LITTLE COLORADO RIVER 1 LEVEE SYSTEM

CITY OF HOLBROOK, NAVAJO COUNTY, ARIZONA NLD SYSTEM ID # 3805020010

PERIODIC INSPECTION REPORT NO 1
GENERALIZED EXECUTIVE SUMMARY

FINAL SYSTEM RATING: MINIMALLY ACCEPTABLE FINAL RATING DATE: MAY 06, 2015

Page 4 of 4 Figure 1-1

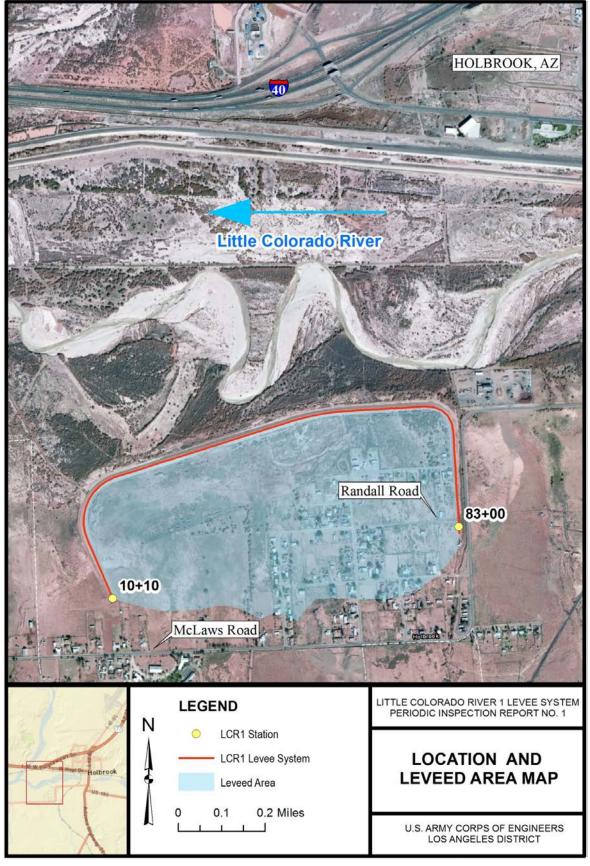
- Erosion rills were observed on the landside slope for the entire extent of the levee.
- Rodent holes were observed at several locations on the landside slope.

• Holes were observed in the access road adjacent to the riverside toe at the downstream end of the levee.
